TOWN OF NEWINGTON

TOWN PLAN AND ZONING COMMISSION

Subject: **Petition #16-20: Special Permit (Sec. 6.11: Service, Sale, Repair, Rental or Storage of Motor Vehicles) for a Gas Station/Convenience Store at 4 Hartford Avenue. Diyala LLC, applicant; Newington Gas Distributors LLC, owner; Jawa Shalo, 3 Bucks Crossing, Cromwell CT, contact.**

Subject: **Petition #17-20: Site Plan Approval at 4 Hartford Avenue. Newington Gas Distributors LLC, owner; Dilaya LLC, applicant; Jawa Shalo, 3 Bucks Crossing, Cromwell CT, contact.**

SHEET 1 OF 7
DATE 3/20/20
REVISED

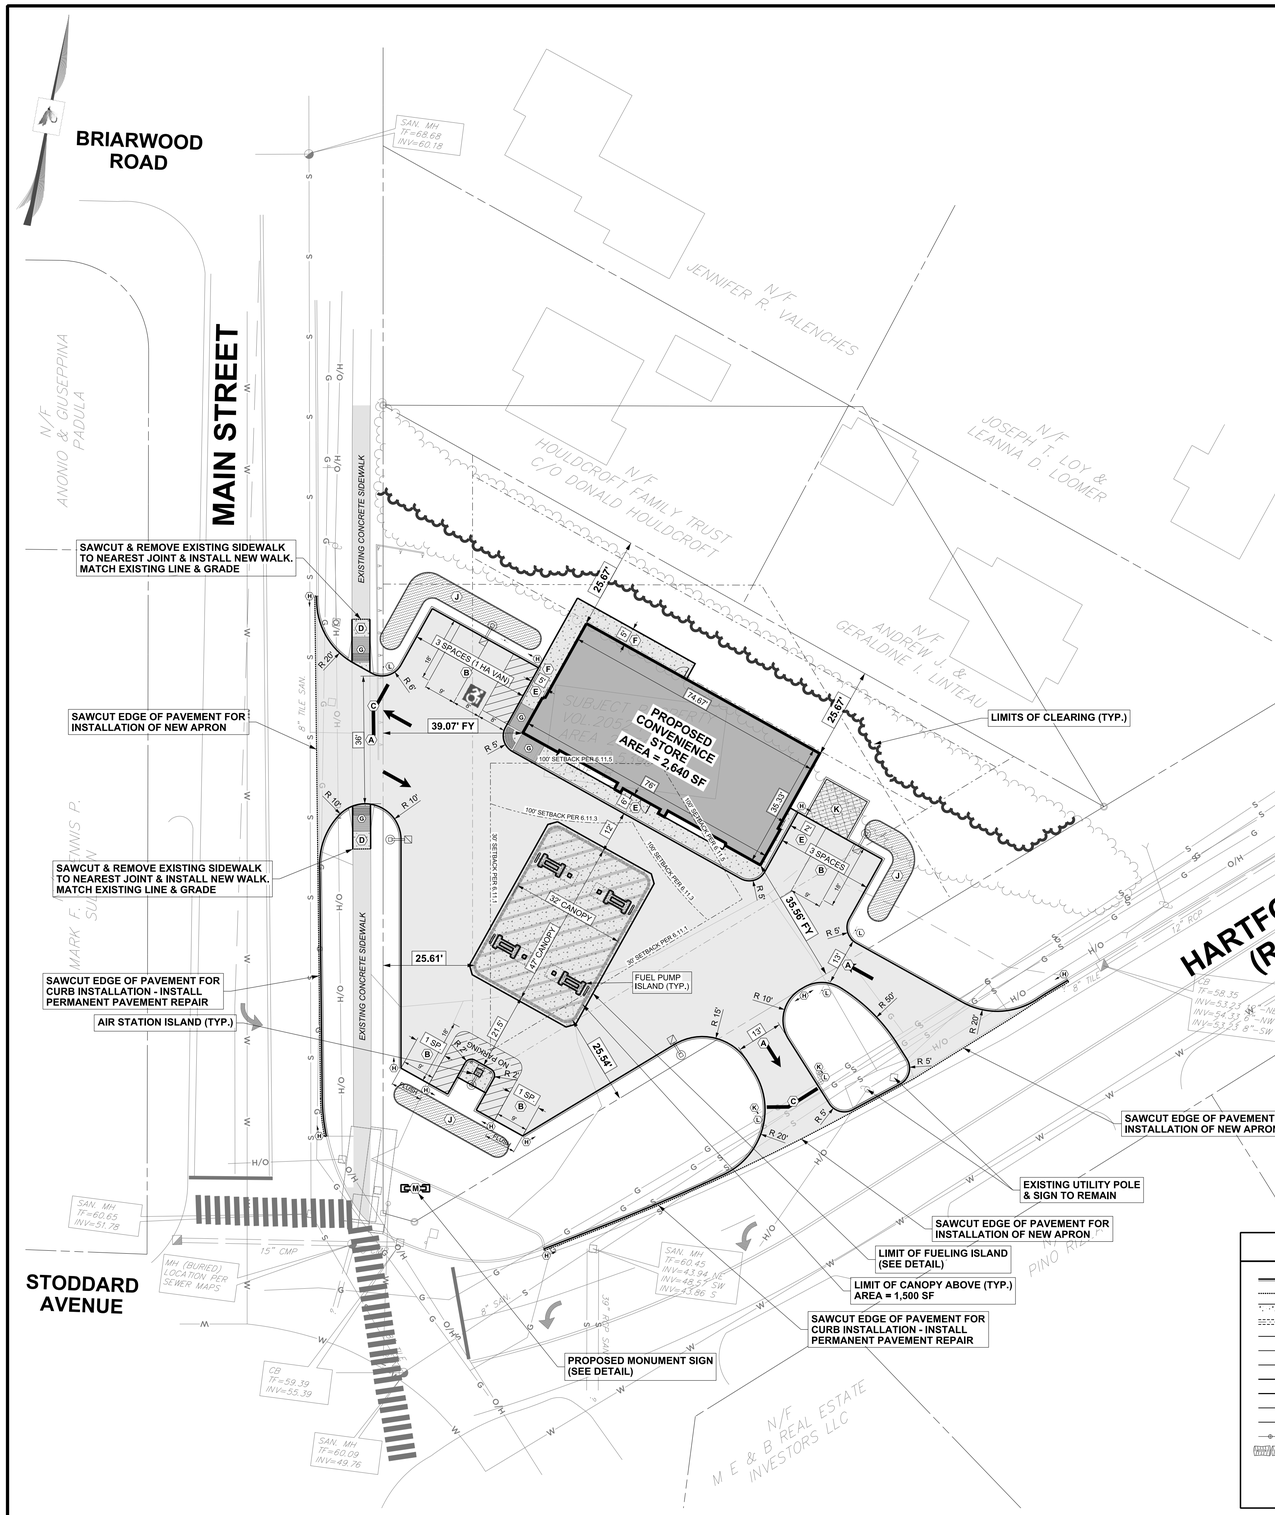
1. "Entrances and exits for any use approved under [Section 6.11] shall be at least 100 feet from a religious institution, school, playground, hospital or any residence." Please explain how the site plan complies with that requirement (Section 6.11.3).

2. Distances and bearings of all boundary lines must be shown, and acreage (Section 5.3.4.2.B).

6. Please include an endorsement block on the cover sheet as follows:

SHEET 2 OF 7

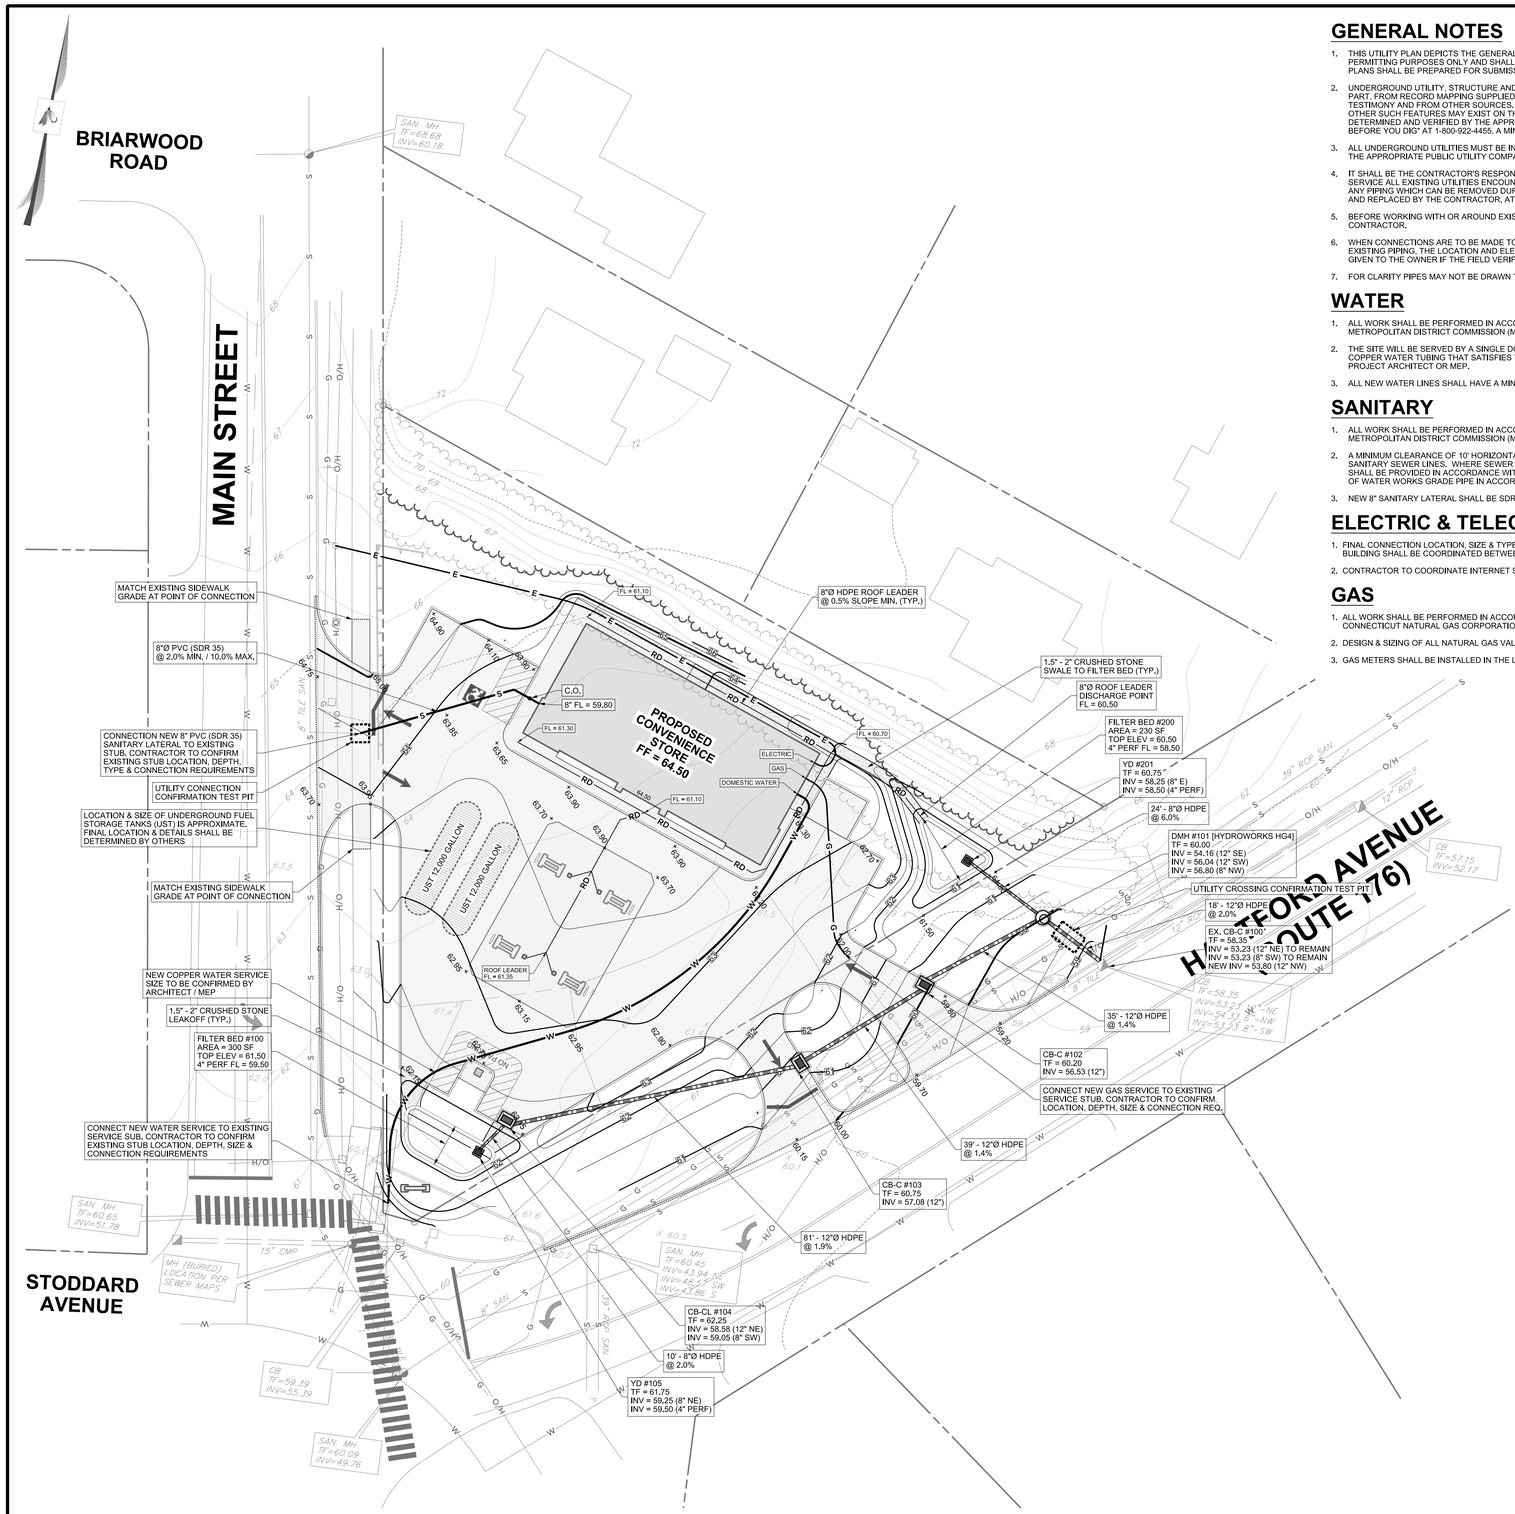
3. The trash enclosure appears to be mislabeled "K" rather than "I".

SHEET 6 OF 7

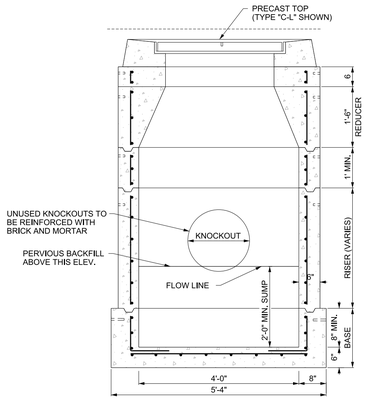
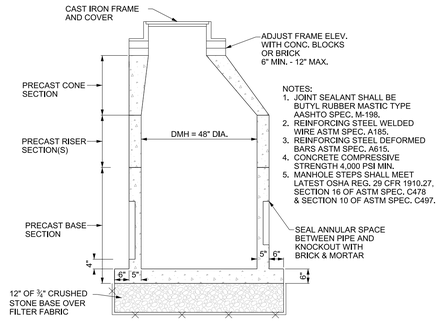
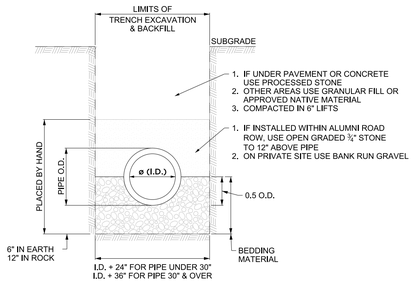
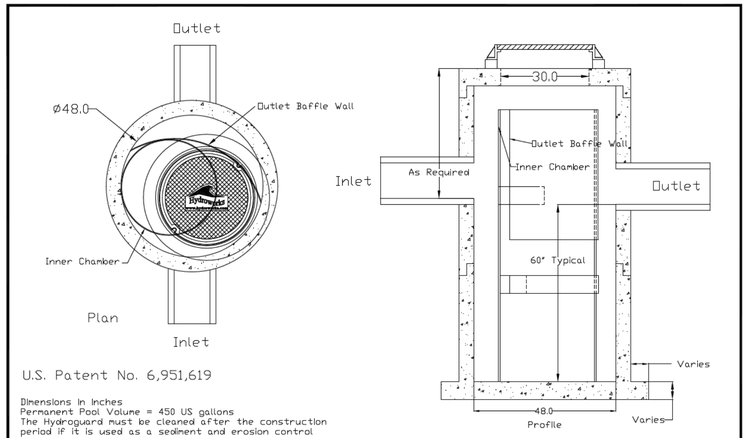
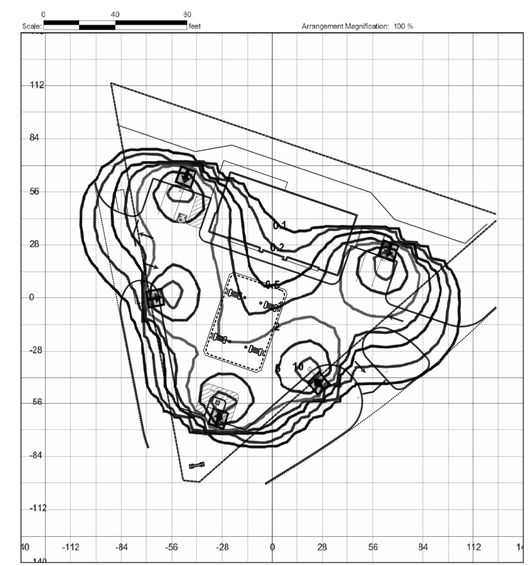
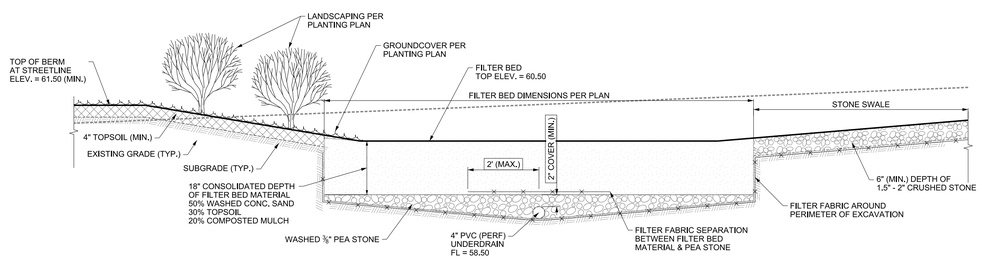
4. Sheet #7 is mislabeled "6 of 7".
